| REFERENCE:          | Nova Bus Manuals                            |
| RS N°:              | MQR 7621-767                                |

| SUBJECT:       | Radius rod bolts                 |
| JUSTIFICATION: | Radius rod bolts may come loose. |

*Figure 1 - Front Axle Radius Rods (4x)*

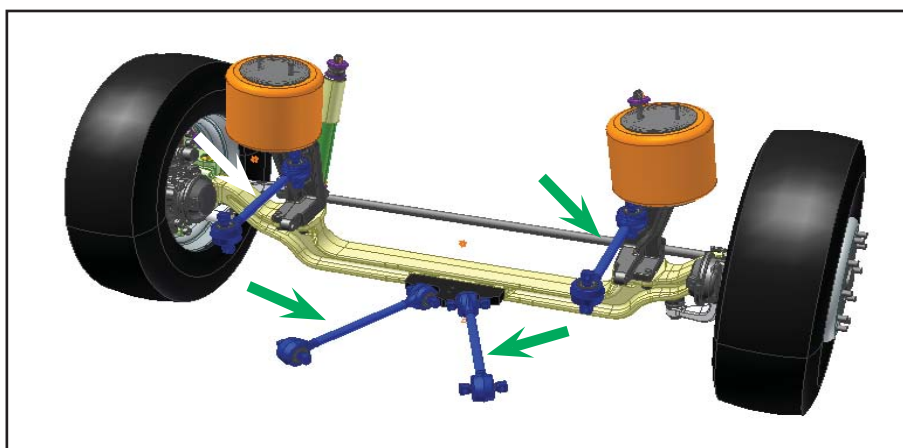
- 1.2. Locate the four radius rods on the front axle. See Figure 1.

- 1.3. Proceed with a torque test to 180 lb-ft (240 N•m) on all 16 radius rods bolts. If the bolt turns before reaching the torque test level, go to level 2.
- 1.4. Torque all 16 radius rod bolts to 205 lb-ft (275 N•m). Use the proper torque sequence shown in section 04: **FRONT SUSPENSION** of the Nova Bus maintenance manual. After torquing each bolt, apply a different coloured torque seal from the one originally used.

Figure 2 - Middle Axle Radius Rods (4x)

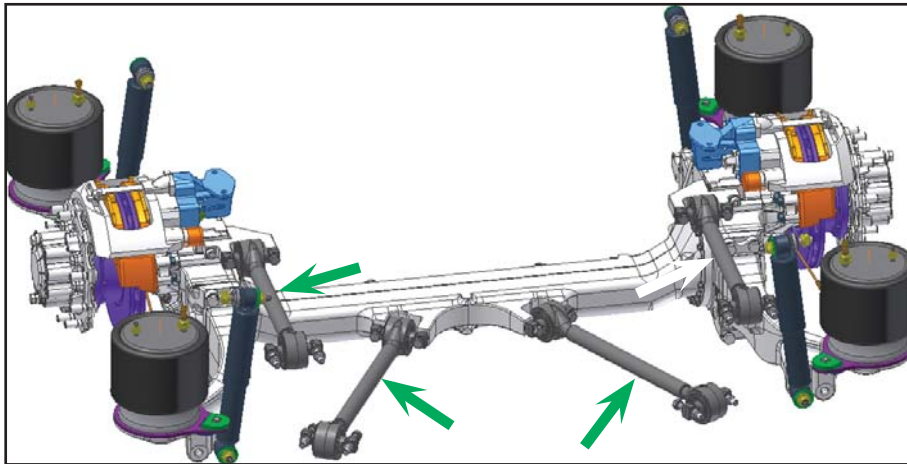
- 1.5. Locate the four radius rods on the middle axle. See Figure 2.

- 1.6. Repeat steps 1.3 & 1.4.  
1.7. Locate the four radius rods on the rear axle. See Figure 3.

Figure 3 - Rear Axle Radius Rods (4x)

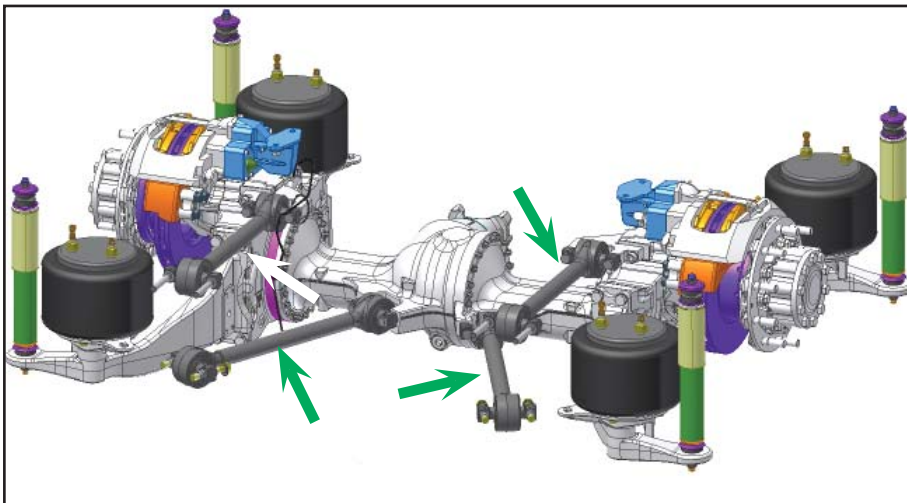
- 1.8. Repeat step 1.3.  
1.9. Torque all 16 radius rod bolts to 205 lb-ft (275 N•m). Use the proper torque sequence shown in section 05: **REAR SUSPENSION** of the Nova Bus maintenance manual. After torquing each bolt, apply a different coloured torque seal from the one originally used.  
1.10. Lower the vehicle.  
1.11. The vehicle may be returned to service.

Figure 4 - Front Axle Radius Rod Hardware

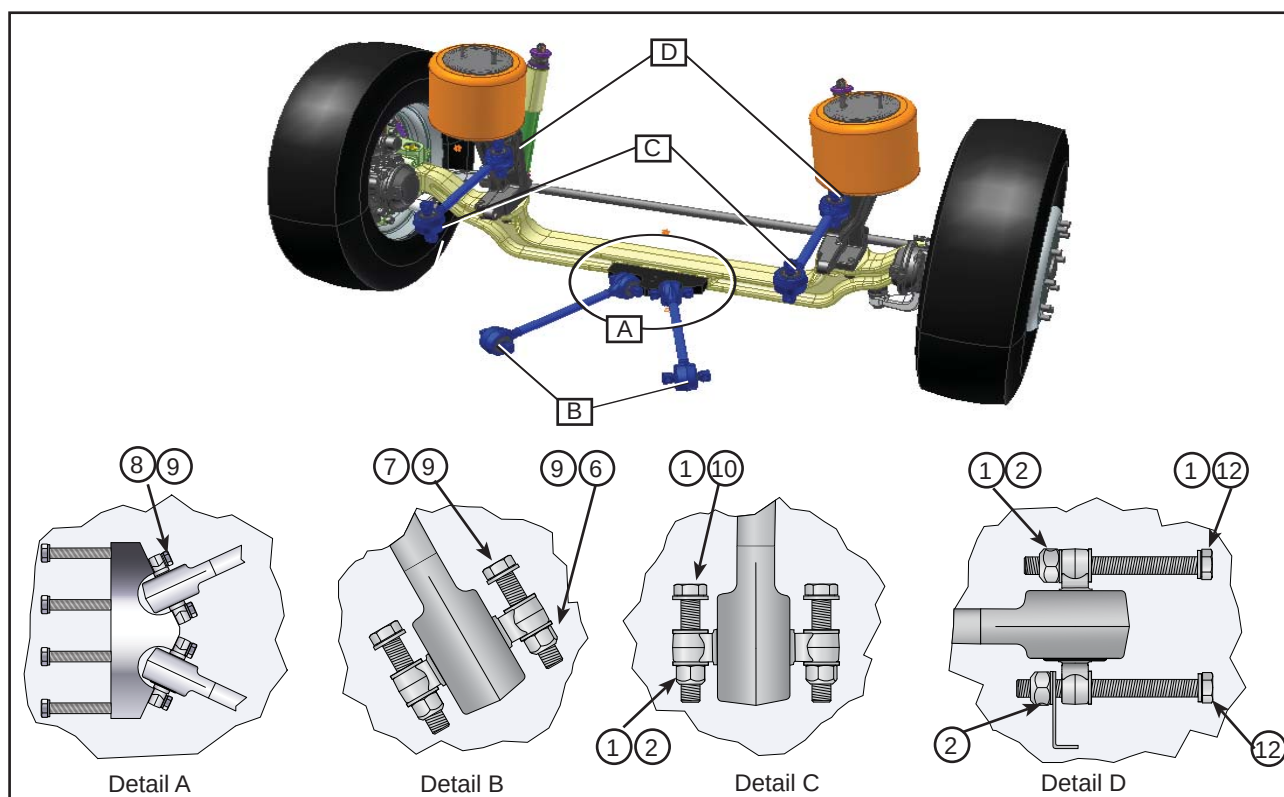
- 2.2. Replace with a new bolt. Also replace the locknut and the Nordlock washer if present. Apply anti-seize compound, Never-Seeze or equivalent, on the new bolt threads. See Figure 4, 5 and 6. Item numbers in the Figures refer to item # column in the part list on page one.

Always replace the two bolts of a radius rod end even if only one is found to be under-torqued. Change the bolts **ONE AT A TIME** to avoid any shift in axle alignment.

- 2.3. Torque the new bolts to 180 lb-ft (240 N•m).
- 2.4. If working on the front or middle axle, return to step 1.4. If working on the rear axle, return to step 1.9. ❖
